Technical Service Bulletin (TSB)
Telematics Box Module (TBM) Firmware Over The Air (FOTA) Software Updating from 4.37 to 4.38

REFERENCE:	TSB: 08-039-25 GROUP: 08 - Electrical	Date:	February 19, 2025	REVISION:	—
VEHICLES AFFECTED:	2021 - 2024 (RU) Chrysler Pacifica 2021 - 2024 (WD) Dodge Durango 2021 - 2024 (MP) Jeep Compass This bulletin applies to vehicles equipped with Global Telematics Box Module (Sales Code RDG).	MARKET APPLICABILITY:			
		<input checked="" type="checkbox"/> NA <input type="checkbox"/> MEA <input type="checkbox"/> SA <input type="checkbox"/> IAP <input type="checkbox"/> EE <input type="checkbox"/> CH			
CUSTOMER SYMPTOM:	Customers may not experience the following: <ul style="list-style-type: none"> Update URL's for ADA's whitelist – to collect data from ADAS customer. No customer impact. No customer symptoms. Other Software Enhancements included: <ul style="list-style-type: none"> Improves vehicle data communication with server for App data management performance. 				
CAUSE:	TBM Software

Fig. 1

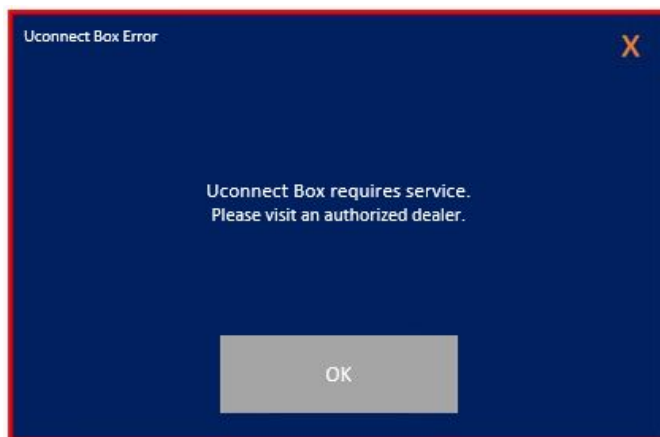
Message display on the radio screen, “Uconnect Box requires service. Please visit an authorized dealer.” Fig. 1, with no active or stored Diagnostic Trouble Codes (DTCs) set by the TBM.

NOTE: “Uconnect Box requires service.” message can be triggered by different reasons. For an issue on a new vehicle recently switched to customer mode, please follow the New Vehicle Preparation procedure to resolve the issue. For the customer vehicle with intermittent concerns, please check the TBM, antenna and instrument panel harness connections to fix related DTC issues.

**Fig. 2**

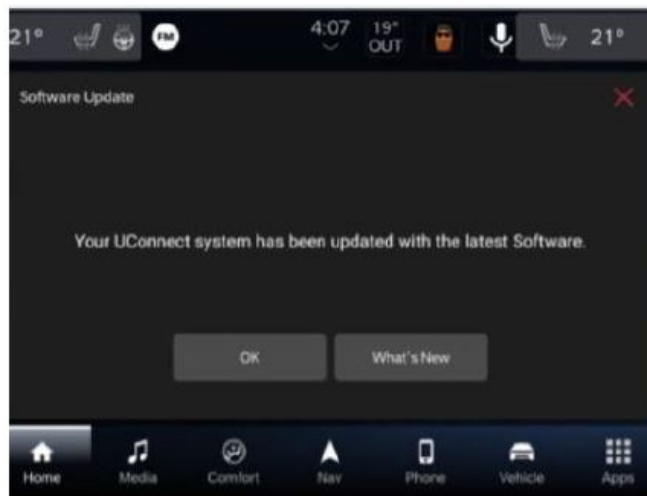
1. The vehicle needs to be in 'Park'. The ignition needs to be in the off position.
2. If the customer selects “Update Now” [Fig. 2](#) they can shut off the vehicle and leave. The update will be completed automatically.
